Title - Sujet Timber Training Wall Repairs	
Solicitation No. - N° de l'invitation F1700-150464/A	Amendment No. - N° modif. 001
Client Reference No. - N° de référence du client	Date 2015-09-10
GETS Reference No. - N° de référence de SEAG PW-\$PWY-026-7603	
File No. - N° de dossier PWY-5-38145 (026)	CCC No./N° CCC - FMS No./N° VME
Solicitation Closes - L'invitation prend fin at - à 02:00 PM on - le 2015-09-17	Time Zone Fuseau horaire Pacific Daylight Saving Time PDT
F.O.B. - F.A.B. Plant-Usine: <input type="checkbox"/> Destination: <input checked="" type="checkbox"/> Other-Autre: <input type="checkbox"/>	
Address Enquiries to: - Adresser toutes questions à: Liu (PWY), Patty	Buyer Id - Id de l'acheteur pwy026
Telephone No. - N° de téléphone (604) 775-6227 ()	FAX No. - N° de FAX (604) 775-6633
Destination - of Goods, Services, and Construction: Destination - des biens, services et construction: DFO - Steveston Wingdam No. 2 - Richmond, BC

Amendment 001 has been raised to incorporate answers to questions provided by potential bidders and to add Drawing # 37071-007788-00-MA-DRD-1501_RevC.

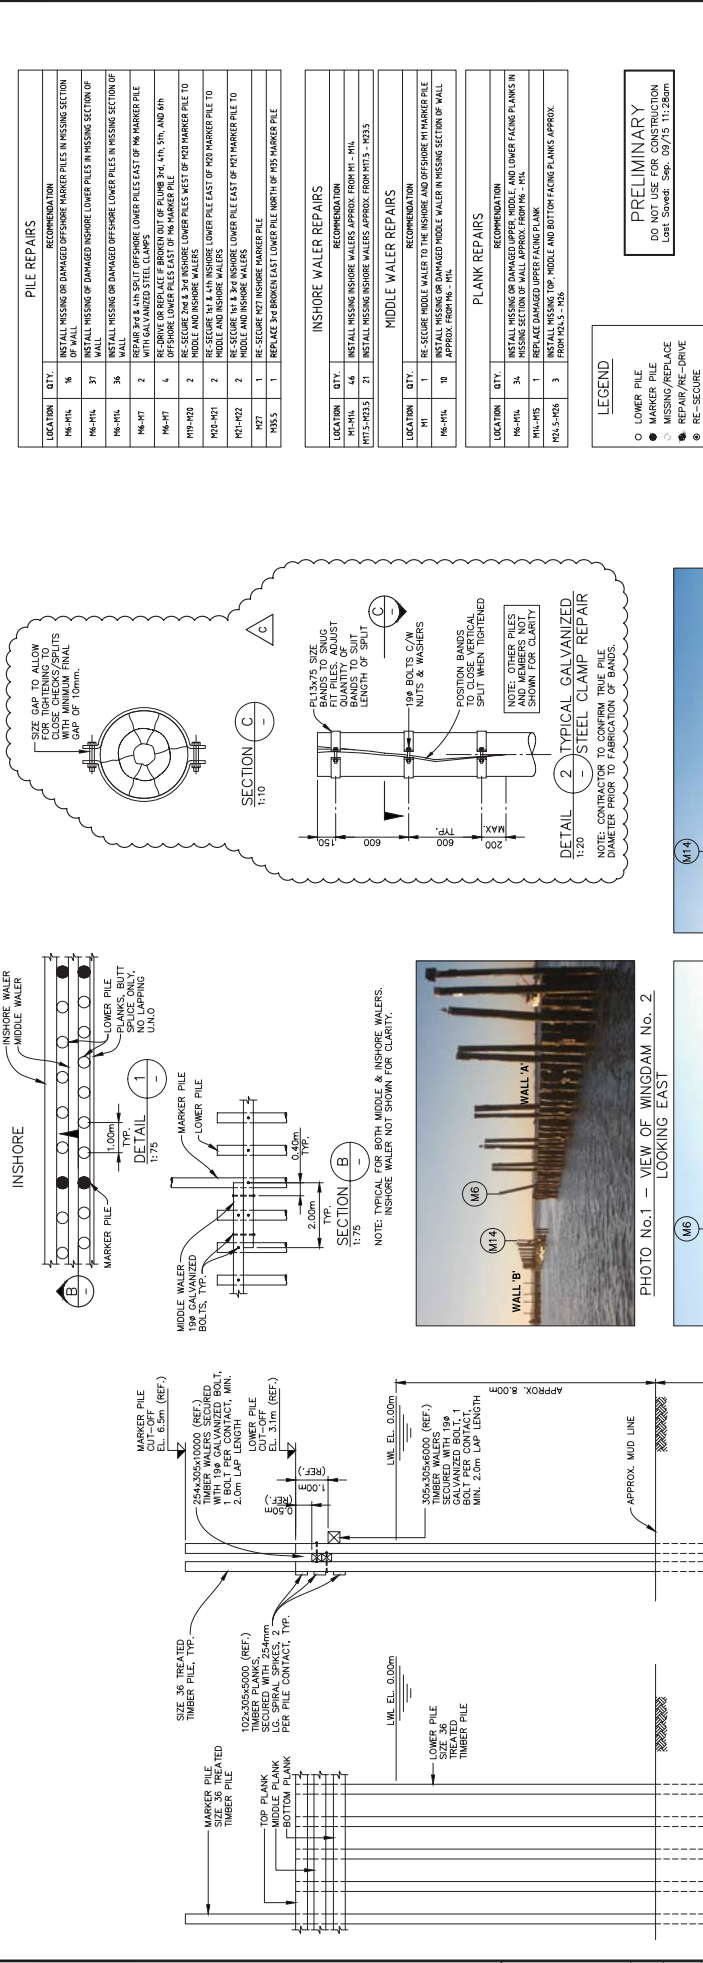
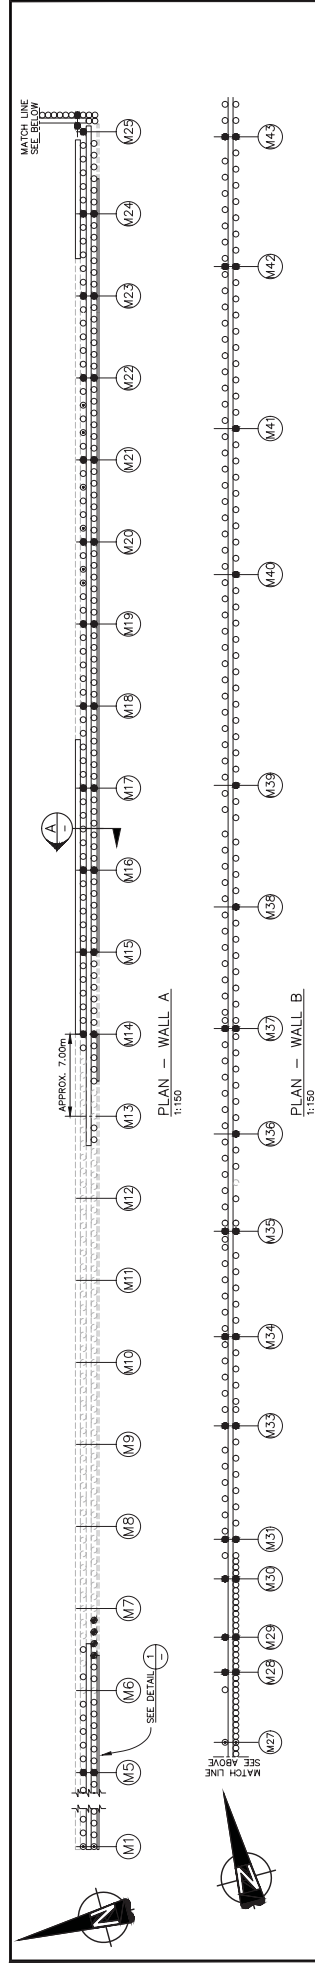
#4 - Regarding Bid Item 9 – please provide a drawing or details of what the galvanized steel pile clamps are supposed to look like. I'm not sure if you are looking for a steel band clamp (width, gauge??) or a more substantial bolted structural clamp (length, steel gauge, # & size of bolts, etc.).?

Steel clamps for split pile repairs shall be galvanized PL 13 mm x 75 mm size band to snug fit piles typically spaced at 600 mm throughout the length of the split. The clamps shall be positioned to close the split pile when tightened and shall use 19 mm diameter galvanized bolts complete with nuts and washers to close the clamps for a snug fit around the pile. Note that clamps shall be sized for a snug fit

and the contractor shall confirm the true clamp size and pile diameter prior to fabrication. Shimming of steel clamps shall not be permitted. View attached drawing.
